**Minutes of the North Carolina Building Code Council
December 10, 2019
Raleigh, NC**

Part B – New Petition for Rulemaking

**FIGURE AM105.2
TYPICAL DECK GIRDER SPANS**

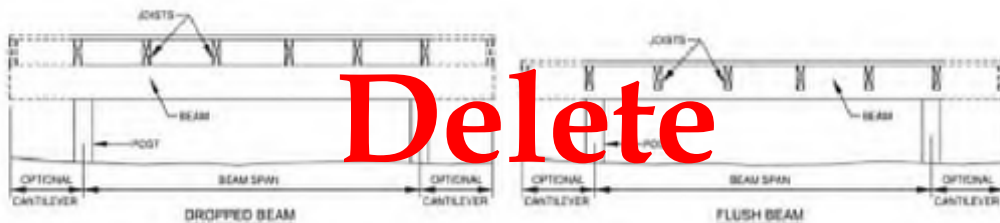
Item B – 5 Request by David Smith, representing the Residential Ad-hoc Committee to amend the 2018 NC Residential Building Code, Appendix M as follows:

~~AM105.2 Girder span for uncovered porches and decks.~~ Maximum allowable spans for wood deck girders, as shown in Figure AM105.2, shall be in accordance with Table AM105.2. Girder plies shall be fastened with two rows of 10d (3 inch × 0.128 inch) nails minimum at 16 inches (406 mm) on center along each edge. Girders shall be permitted to cantilever at each end up to one fourth of the actual beam span. Splices of multispan beams shall be located at interior post locations.

FIGURE AM106.1
TYPICAL DECK JOIST SPANS

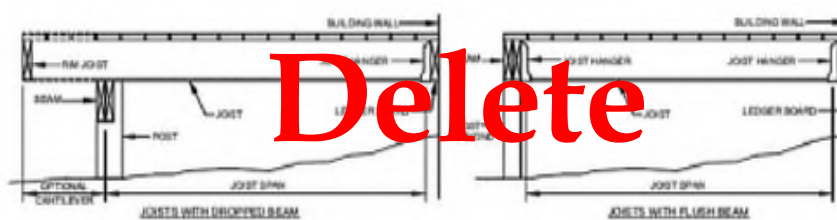
~~AM106.1 Joist spans for uncovered porches and decks and cantilevers.~~ Joists spans shall be based upon Table R502.3.1(2) with 40lbs per sq ft of live load and 10 lbs per sq ft of dead load. Floor joists for exterior decks may be cantilevered per Table R502.3.3(1). Maximum allowable spans for wood deck joists, as shown in Figure AM106.1, shall be in accordance with Table AM106.1. Deck joists shall be permitted to cantilever not greater than one fourth of the actual, adjacent joist span.

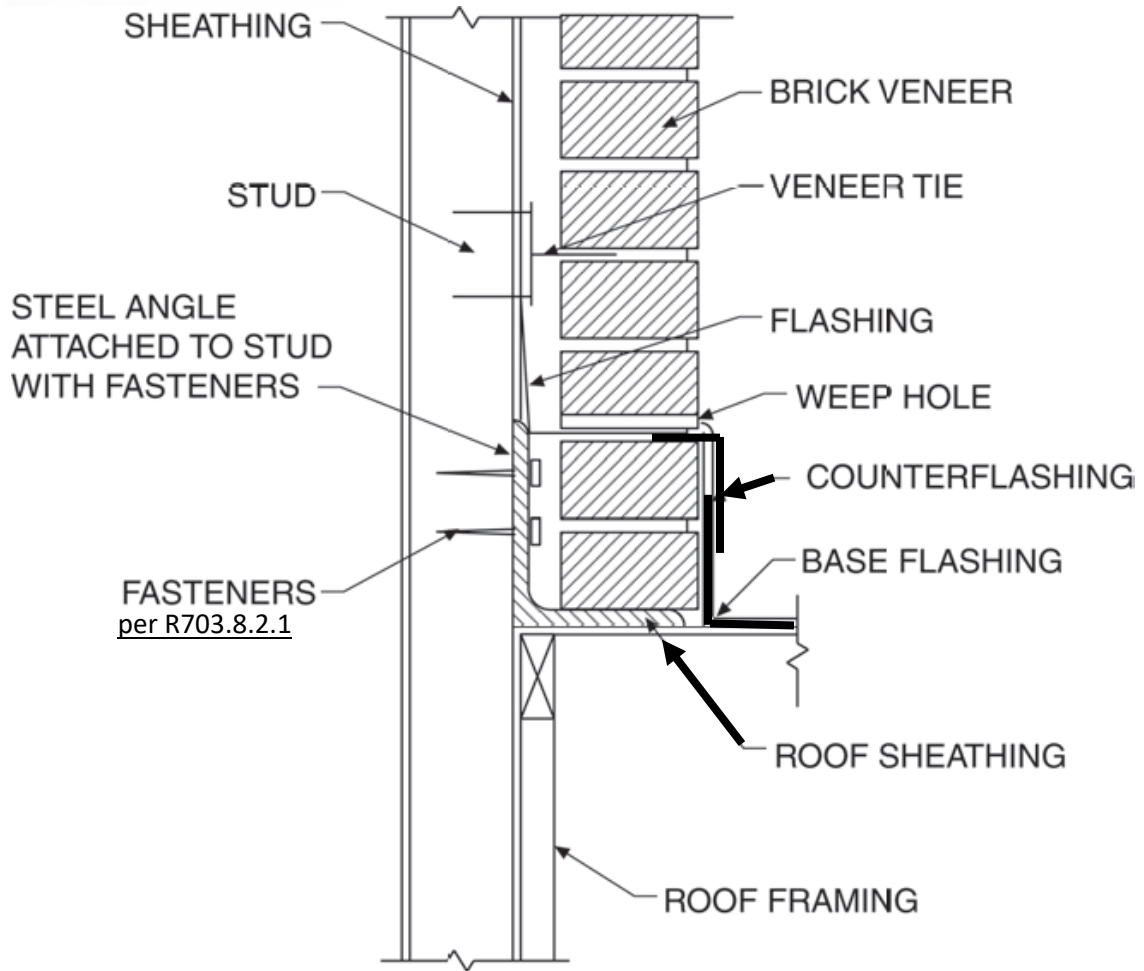
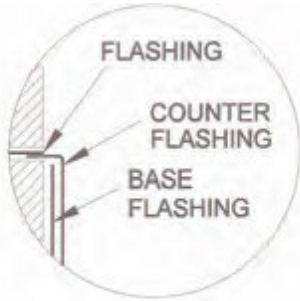
Item B – 10 Request by David Smith representing the Residential Ad-hoc Committee to amend the 2018 NC Residential Code, Section R311.7.5.3 Nosings & Section R312 Guards and Window Fall Protection as follows:

R312.1.3 Opening limitations. Required *guards* shall not have openings from the walking surface to the required *guard* height that allow passage of a sphere 4 inches (102 mm) in diameter.

1. The triangular openings at the open side of stair, formed by the riser, tread and bottom rail of a *guard*, shall not allow passage of a sphere 6 inches (153 mm) in diameter.

2. *Guards* on the open side of stairs shall not have openings that allow passage of a sphere 4 3/8 inches (111 mm) in diameter.

**FIGURE R703.8.2.2
EXTERIOR MASONRY VENEER SUPPORT BY ROOF MEMBER**

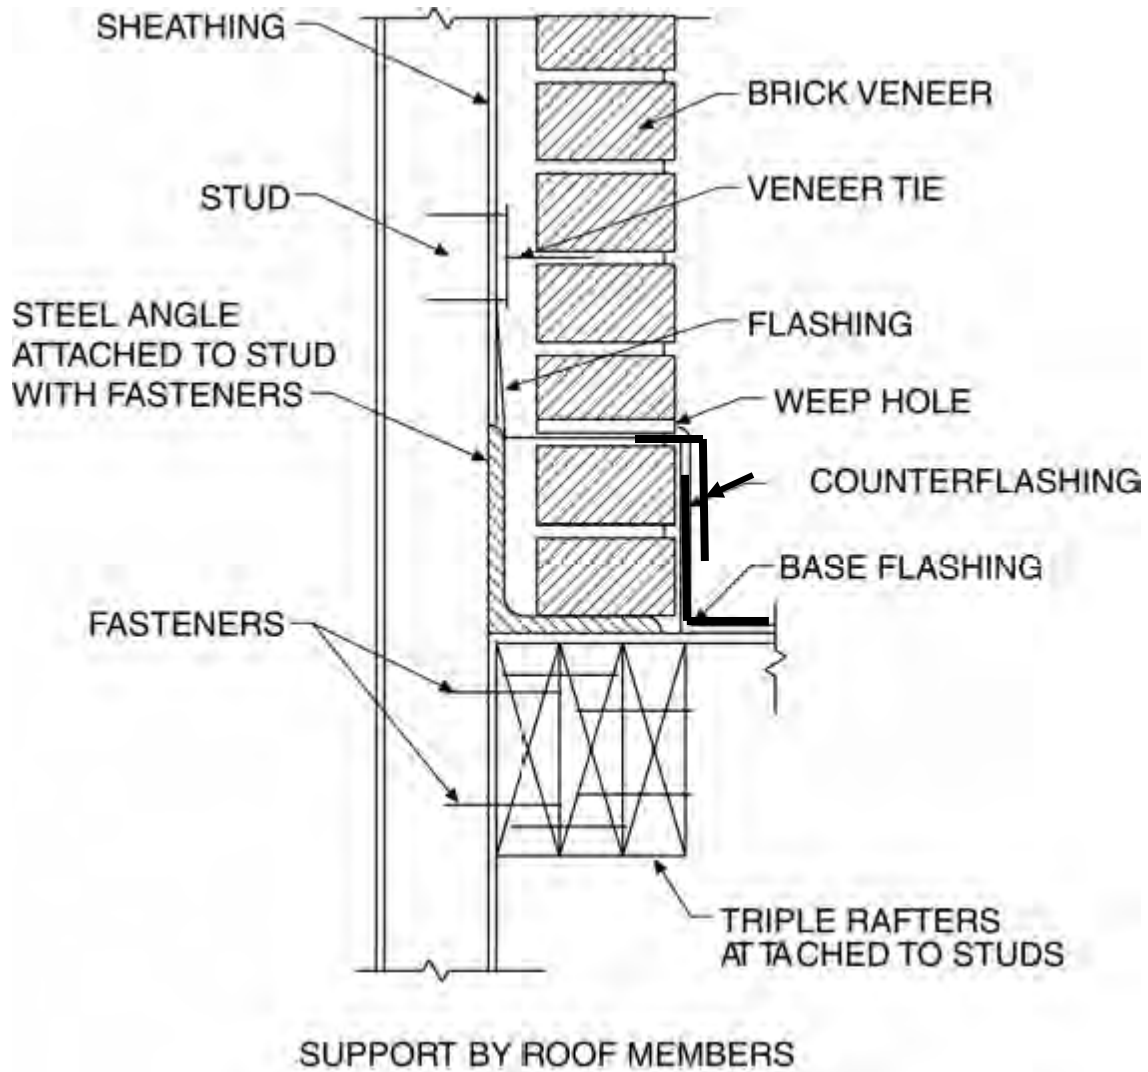
Item B – 11 Request by David Smith representing the Residential Ad-hoc Committee to amend the 2018 NC Residential Code, Section R703.8.2.1 Support by steel angle as follows:

The maximum slope of the roof construction without stops shall be 7:12. Roof construction with slopes greater than 7:12 but not more than 12:12 shall have stops of a minimum 3-inch by 3-inch by 1/4-inch (76 mm by 76 mm by 6.4 mm) steel plate welded to the angle at 24 inches (610 mm) on center along the angle or as approved by the building official.

**Table AM109.1.4
FASTENING OF BRACE (CHOOSE ONE)**

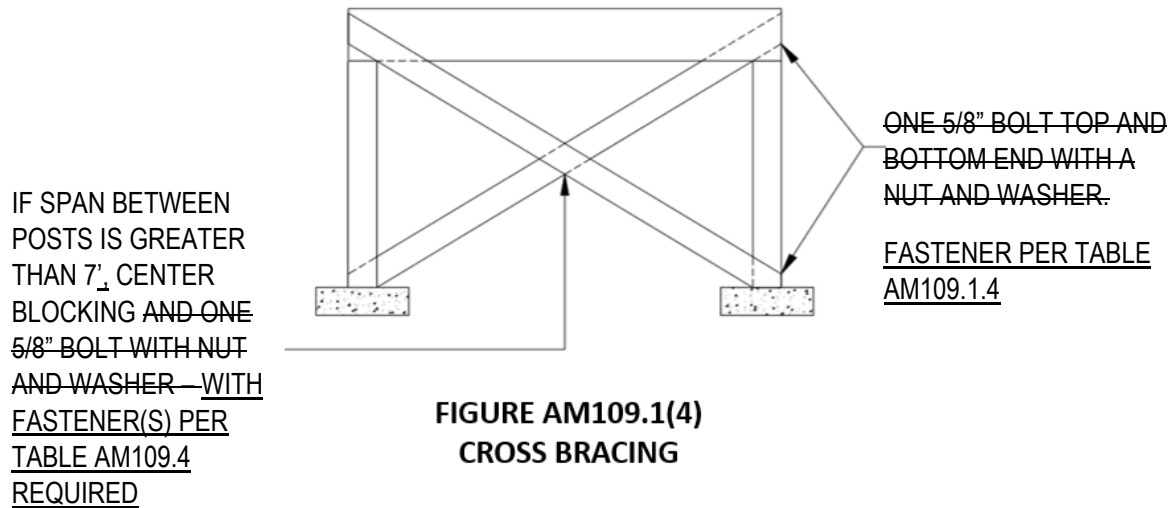
Item C – 1 Request by Jackie Flemming and Doug Allen representing Simpson Strong-Tie to amend the 2018 NC Residential Code, Appendix M, Section AM109.1.4 as follows:

2x6 diagonal vertical cross bracing is permitted to be provided in two perpendicular directions for free standing decks or parallel to the structure at the exterior column line for attached decks. The 2x6 bracing shall be attached to the posts with one of the methods in Table AM109.1.4 ~~5/8-inch (16 mm) hot dip galvanized bolt with nut and washer~~ at each end of each bracing member in accordance with Figure AM109.1(4).
